AMENDMENTS TO THE DRAWING FIGURES

(Serial No. 10/696,791)

REMARKS

Fig. 3A

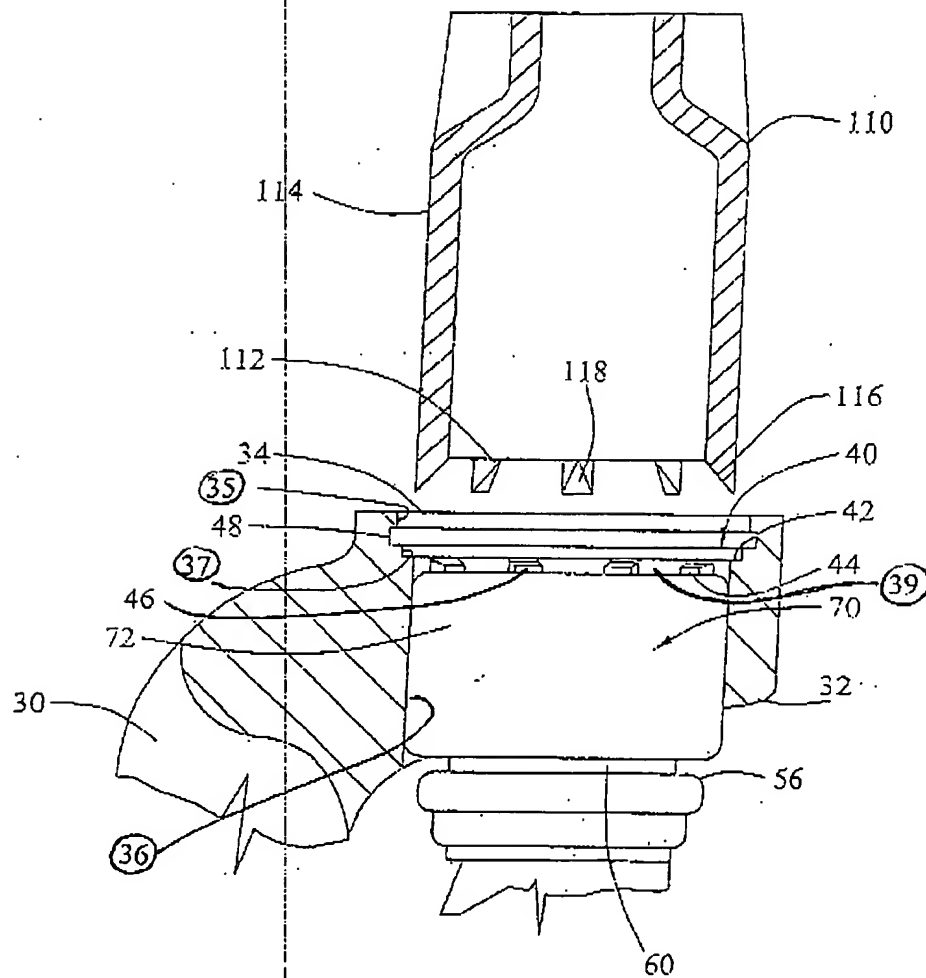
The attached Replacement Sheet contains changes to FIG. 3A. Those changes are marked in red on the Annotated Sheet Showing Changes, which is an appendix to this amendment.

Claims 1-3 and 5-7 stand rejected under 35 U.S.C. 112, first paragraph, for not being satisfactorily described in the specification. Amended Paragraph [0028] and FIG. 3A, taken together, describe and illustrate the location of the "first diameter," "second diameter," "third diameter," "seat," which replaces "shoulder" in the claims, and the "space" 39. Each of these elements is recited in the claims, as amended. The amended specification supports the claims consistently with the statutory requirement. No new matter has been added.
